Document: "Response to Comments for NJDEP comments on Final Remedial Investigation Report for FTMM-02 dated January 2016 (& Landfill Boundary Refinement for FTMM-02 dated January 2016)"

SUBJECT: *Final Remedial Investigation Report for FTMM-02 dated January 2016 (& Landfill Boundary Refinement for FTMM-02 dated January 2016) Fort Monmouth, Oceanport, New Jersey*
PIG000000032

Figure 1 – Revised 2016 Landfill Boundary

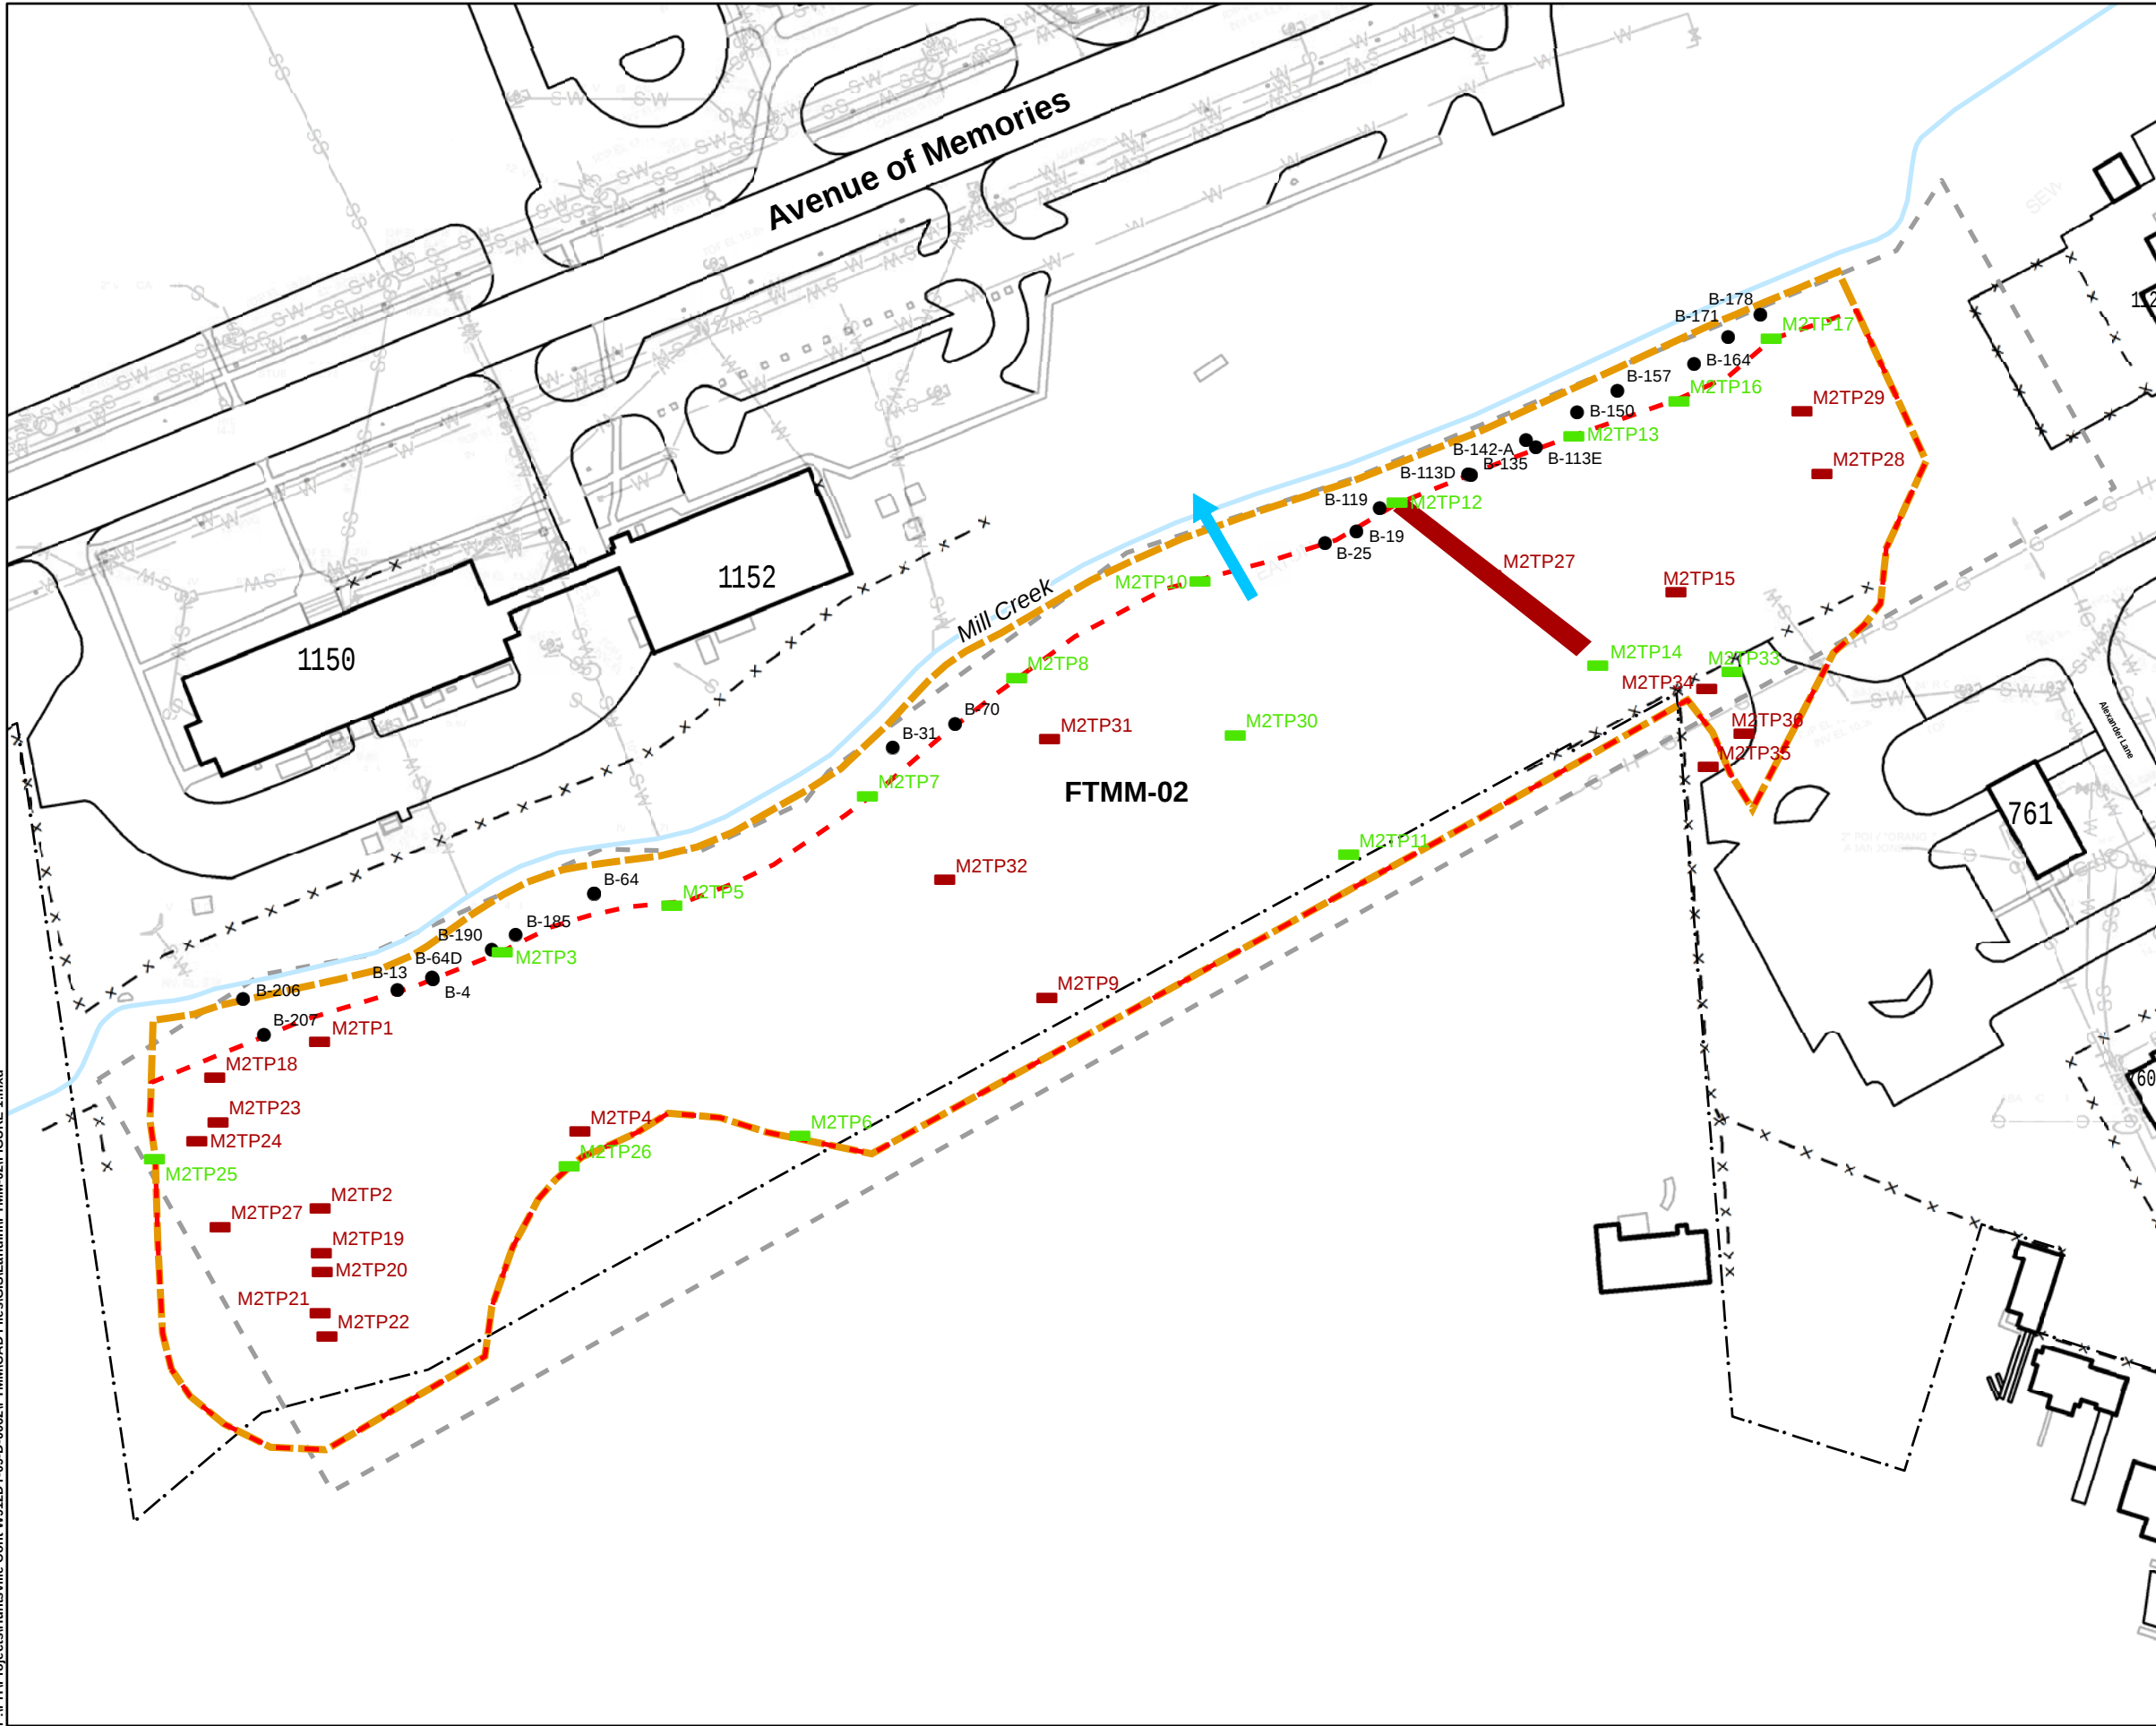
C. COMMENT: *As was indicated during a April 12, 2016 phone conversation with Army representatives, the Department is not in agreement with the categorizations of the test pit findings utilized in determining the boundaries of the landfills, as referenced in Section 2.0 Landfill Boundary Refinement Program and Summary (Appendix A). More specifically, the*

Department does not agree debris of a "scattered nature" or "de minimus" quantity may be presumed as existing beyond the boundaries of a landfill. This would include, for instance, debris as noted in test pits M2TP8 and M2TP10, which are among those test pits with scattered, non-contiguous or de minimus amounts of debris used in Figure A1 of the Landfill Boundary Refinement Report to designate the revised extent of the northern boundary, but which the Department considers located within the landfill boundary.

Unless test pits at anticipated landfill boundaries are free of debris (e.g. M2TP 25, Test Pit 2 at the western boundary noted on Figure A1 above), or it is sufficiently demonstrated areas of scattered, non-contiguous, or de minimus debris are not within the landfill boundaries (e.g., as was suitably demonstrated for the southern boundary of FTMM-02 via submittal of historic aerial photographs, which established the historic and continued presence of the railway and wooded areas), as per the discussion on April 12, those areas at which scattered, non-contiguous and/or de minimus debris is noted are considered landfill material and must also be incorporated into that area at which capping is to be performed.

C. RESPONSE: The FTMM team's detailed evaluation of the landfill boundary did not presume that all debris was outside the landfill boundary. We did, however, use site knowledge, and evidence from extensive test pit operations to make a professional judgment at FTMM-02 on a case-by-case basis that some debris (of a scattered nature and *de minimus*) in select test pits was not contiguous and did not constitute a landfill. The FTMM team believe this is reasonable and appropriate given the wide variety of activities at FTMM over many decades. Although the FTMM team disagrees with the NJDEP regarding the landfill boundary, we reserve the right to: 1) adjust the northern FTMM-02 landfill boundary will be revised so that the soil cover engineering control includes the test pits containing debris of *de minimus* quantity located approximately 40 feet south of Mill Creek or 2) move this material into the existing boundary of the cap and regrade as appropriate.; however, the engineering control will be placed no closer to the creek than the southern edge of the planting buffer indicated in the 2012 *Sanitary Landfill Disruption Approval Construction Closeout Report* by Princeton Hydro, LLC previously submitted to NJDEP. The 2012 Princeton Hydro report details the installation of slope stabilization rip rap located along the northern bank of FTMM-02, subsequent grading of the bank, and the planting buffer installed along Mill Creek.

Figure 1 presents the revised 2016 landfill boundary, test pit locations, and soil borings located north of the 2015 landfill boundary. The soil cover engineering control will be extended to the 2016 boundary and graded to integrate into the existing rip rap. The revised boundary incorporates the test pits described in Response C, and revised engineering control extent includes the borings mentioned in Response B.
